Title - Sujet Culvert Replacement	
Solicitation No. - N° de l'invitation EZ899-152094/A	Amendment No. - N° modif. 003
Client Reference No. - N° de référence du client	Date 2015-03-10
GETS Reference No. - N° de référence de SEAG PW-\$PWY-026-7462	
File No. - N° de dossier PWY-4-37327 (026)	CCC No./N° CCC - FMS No./N° VME
Solicitation Closes - L'invitation prend fin at - à 02:00 PM on - le 2015-03-12	Time Zone Fuseau horaire Pacific Daylight Saving Time PDT
F.O.B. - F.A.B. Plant-Usine: <input type="checkbox"/> Destination: <input checked="" type="checkbox"/> Other-Autre: <input type="checkbox"/>	
Address Enquiries to: - Adresser toutes questions à: Liu (PWY), Patty	Buyer Id - Id de l'acheteur pwy026
Telephone No. - N° de téléphone (604) 775-6227 ()	FAX No. - N° de FAX (604) 775-6633
Destination - of Goods, Services, and Construction: Destination - des biens, services et construction: PWGSC - km 475 Alaska Highway - Alaska Highway, BC

Amendment 003

Figure 1: Crossing Location

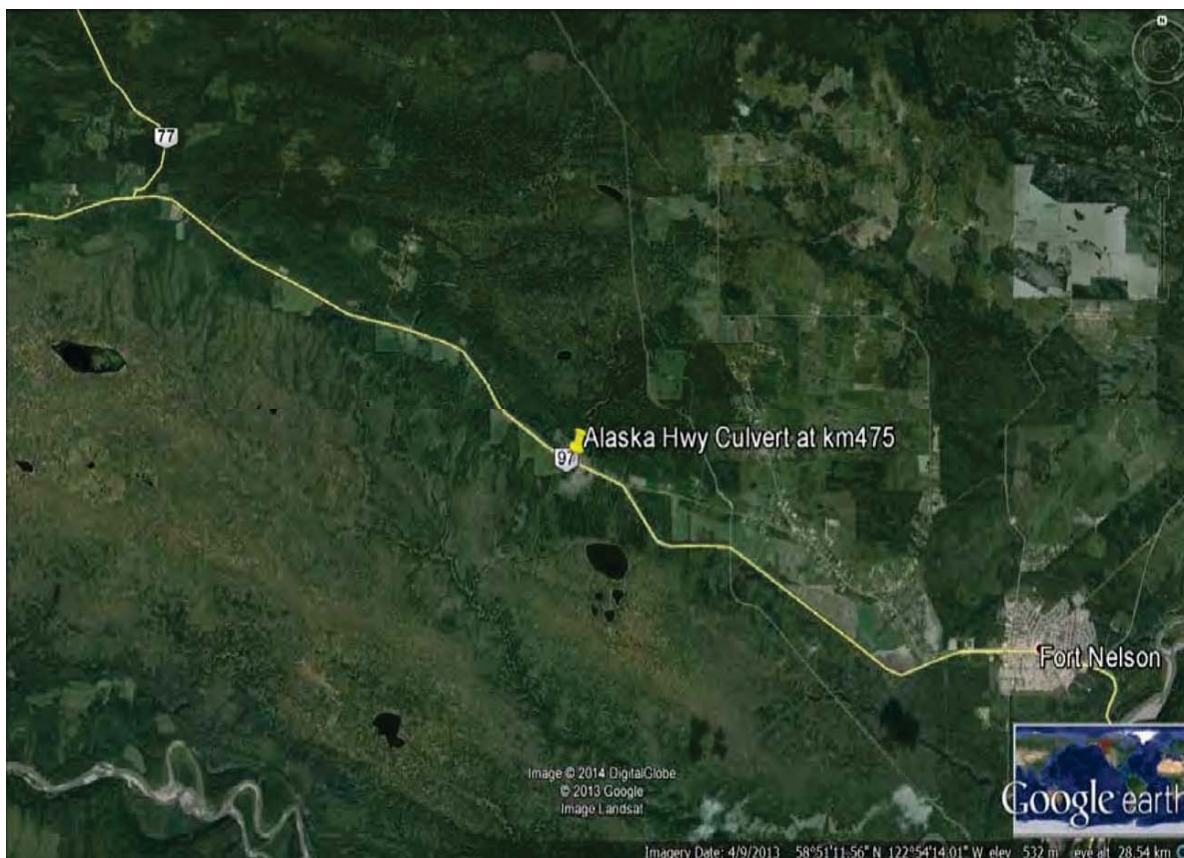
Q1. On page 31 to 33 of the Environmental Effects Evaluation (EEE) report Dated January 2015 there are supposed to be some pictures. Can you please provide us with those pictures as it will be very helpful with regards to bidding this project.

A1. Please view attached Addendum 002.
